MEMORANDUM

Date: March 22, 2016

Re: Construction Contingency Approval: Caleb Dustin Hunking School

SKE-07

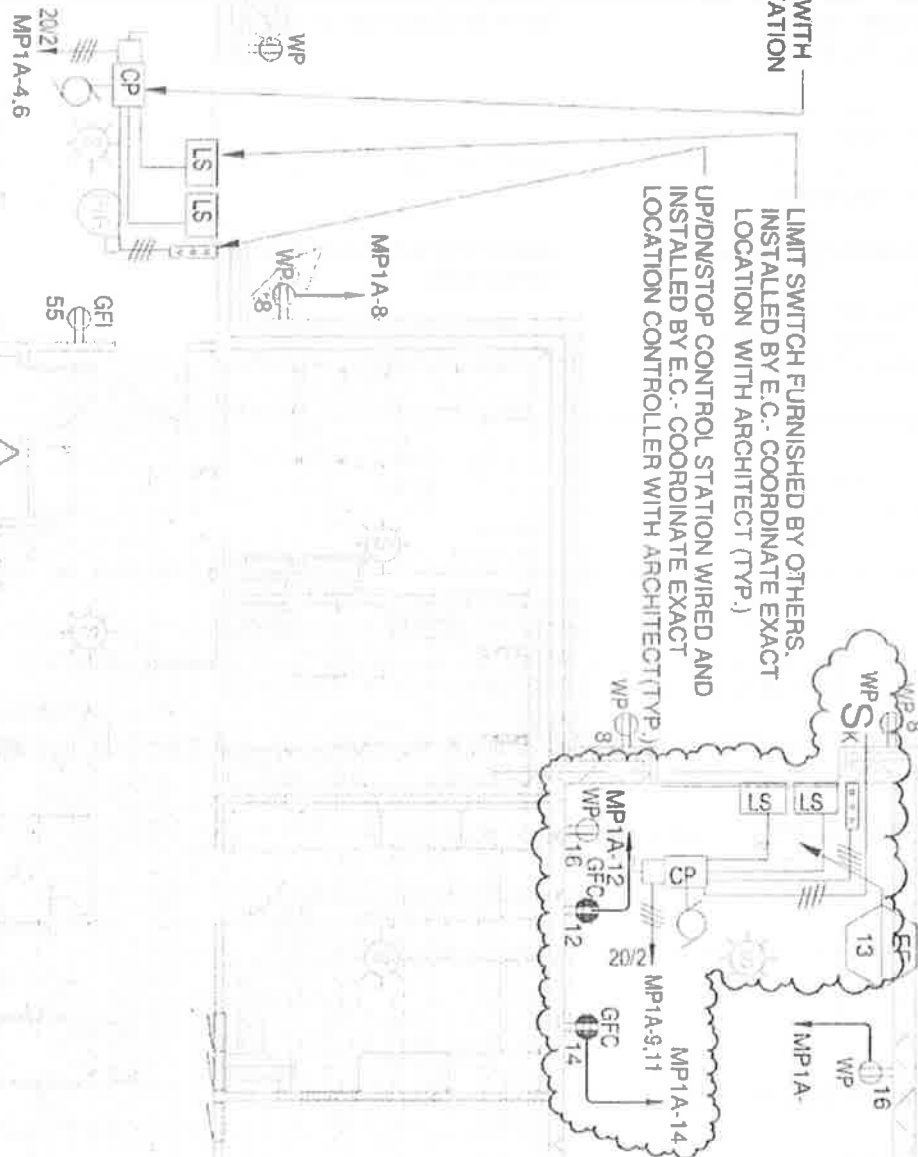
Add door power to overhead door A125 per attached sketch SK-07.

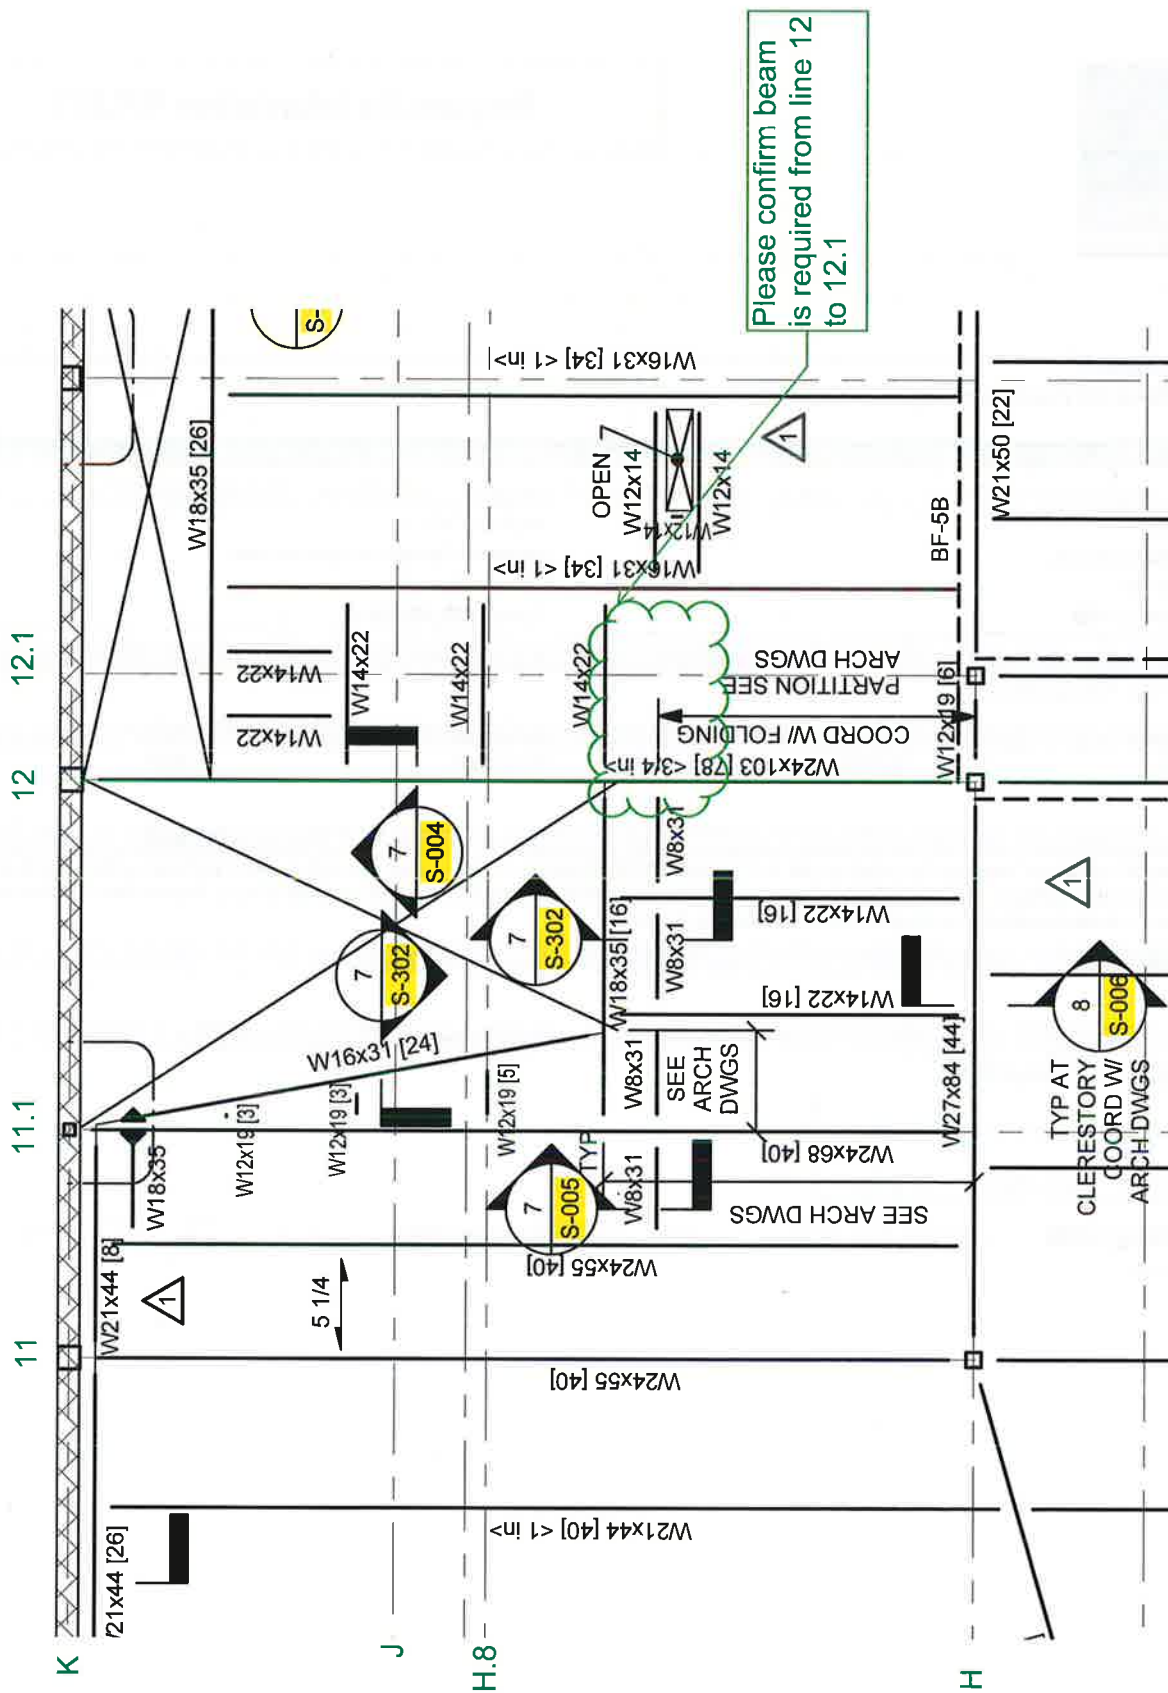
Please see the attached marked up drawings for A-112 and S-122. Drawing A-112 shows the sliding glass partition extending to column line 12.1. Structural drawing S-122 shows W8x31 beams (beams that partition support attaches to) extending to column line 12, please confirm a W8x31 beam is necessary to be installed from column line 12 to 12.1.

W8 steel beam is acceptable as proposed.

1 Partial THIRD FLOOR AREA A - POWER PLAN
SKE-15 SCALE: 1/8" = 1'-0"

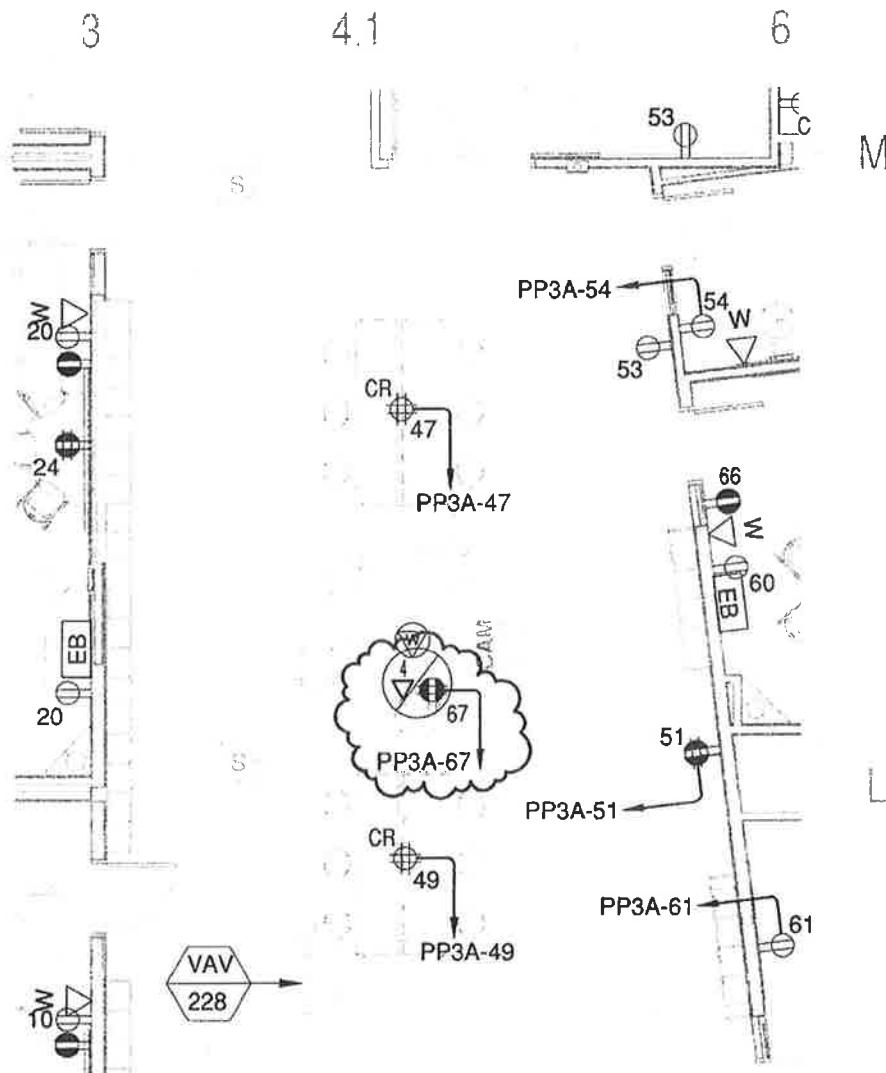
At the direction of the owner, add floor box as described in SK-037 and SKE-15, attached .

**ADDED POKE-THRU DEVICE @ PROJECT
AREA A315**

SKA-039, SKA-040 and SKA-041.

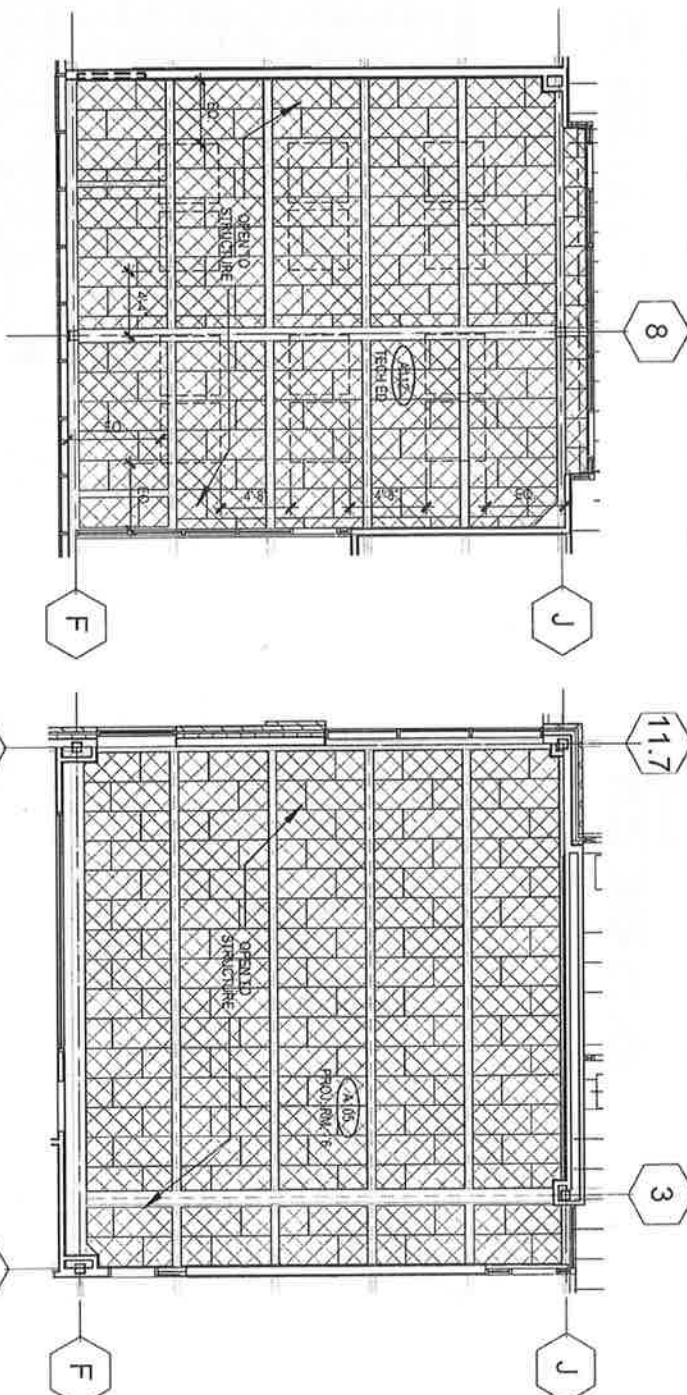
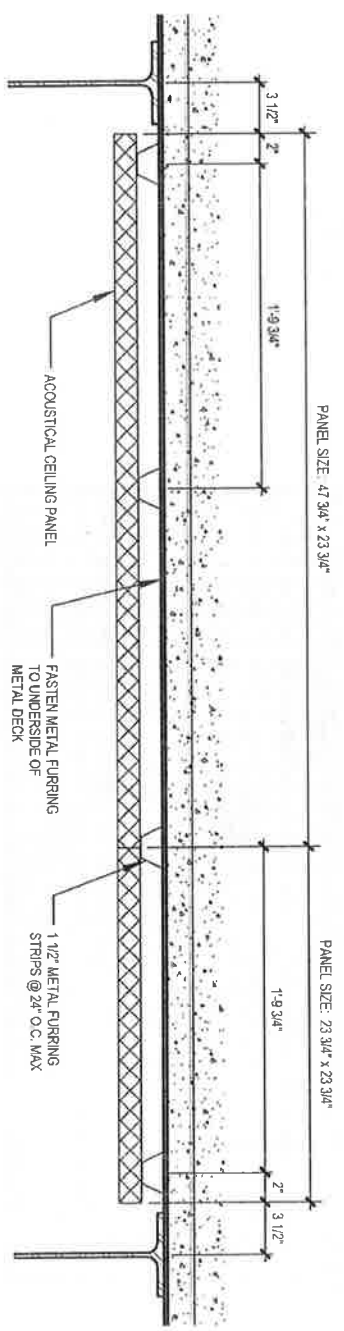
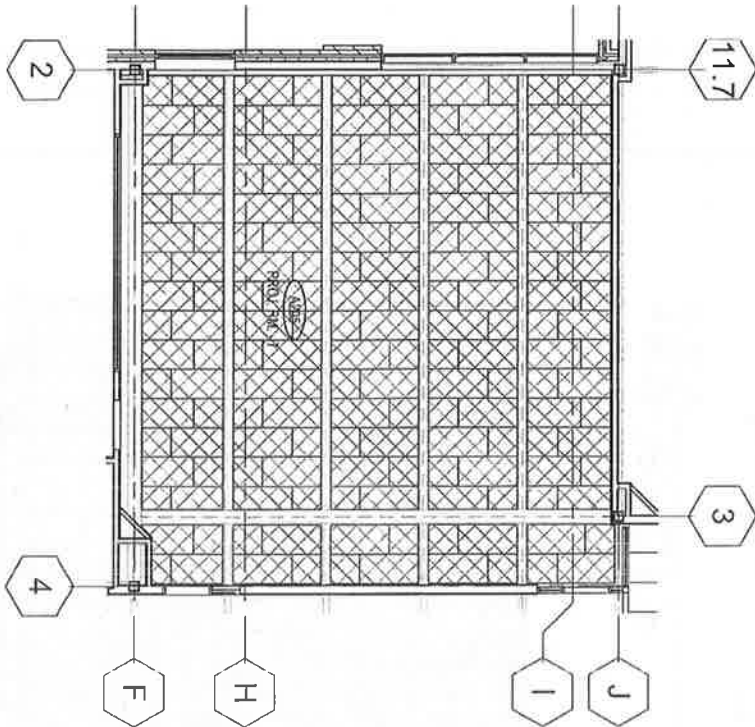
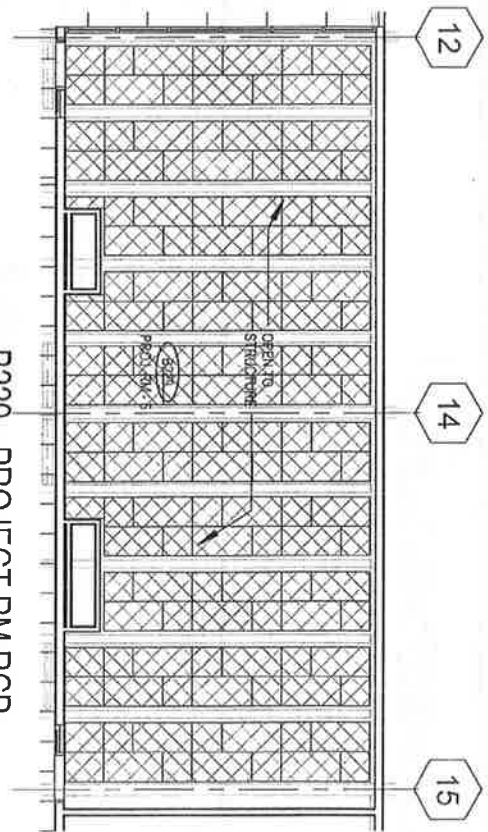
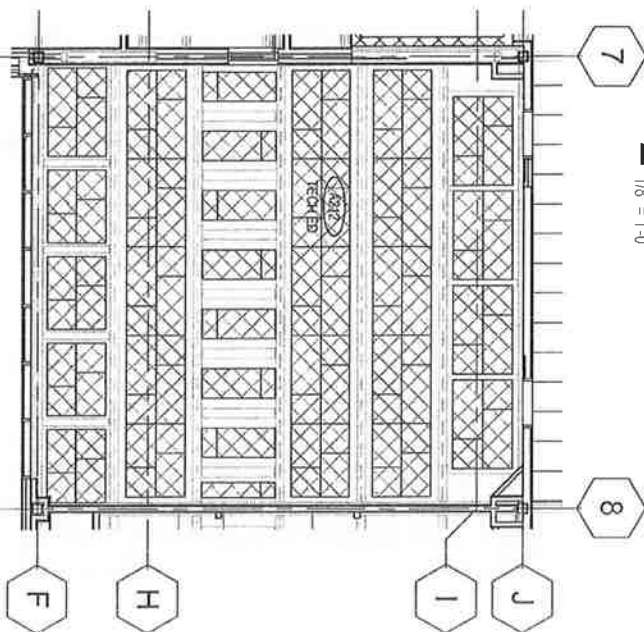
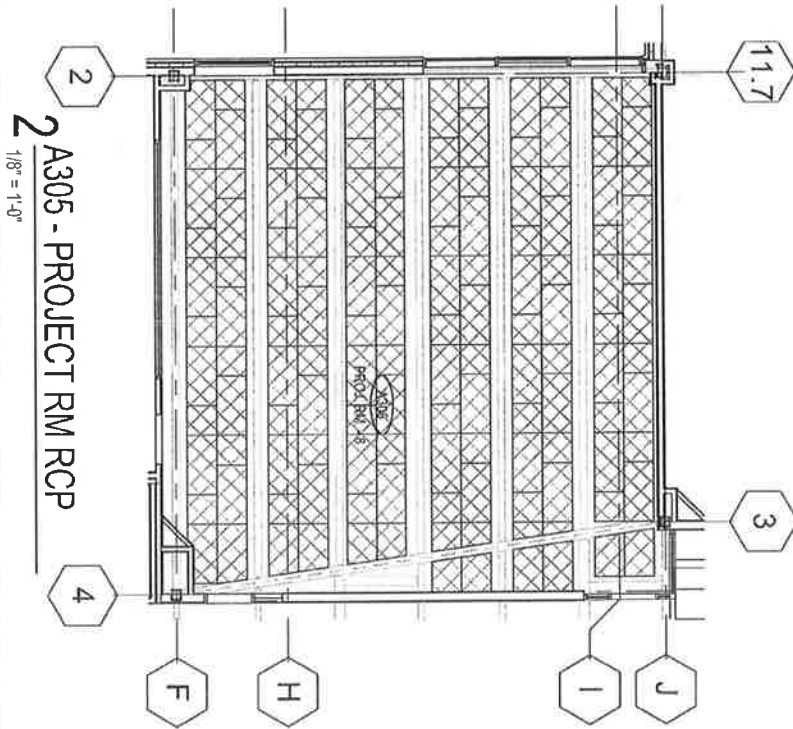
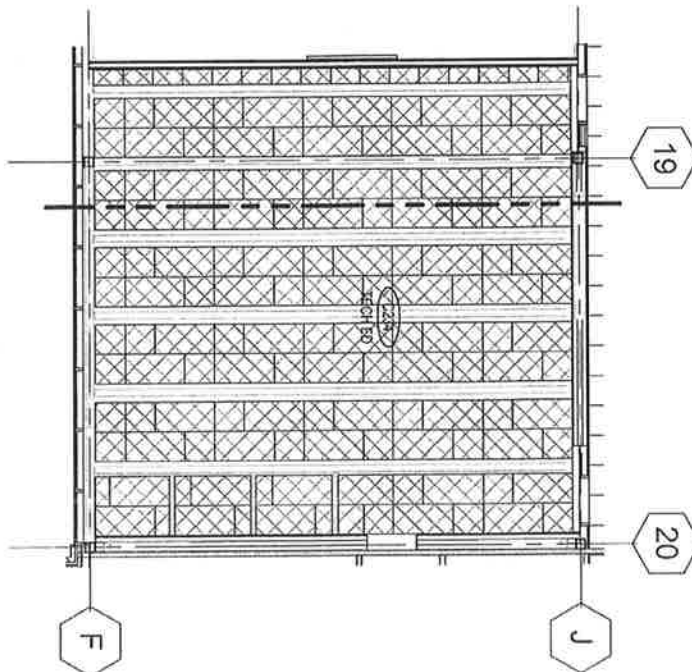
Provide cost for addition of Tectum Finale 1" panels, 24" wide in rooms A105, A112, A205, A212, B229, C234 and A305.
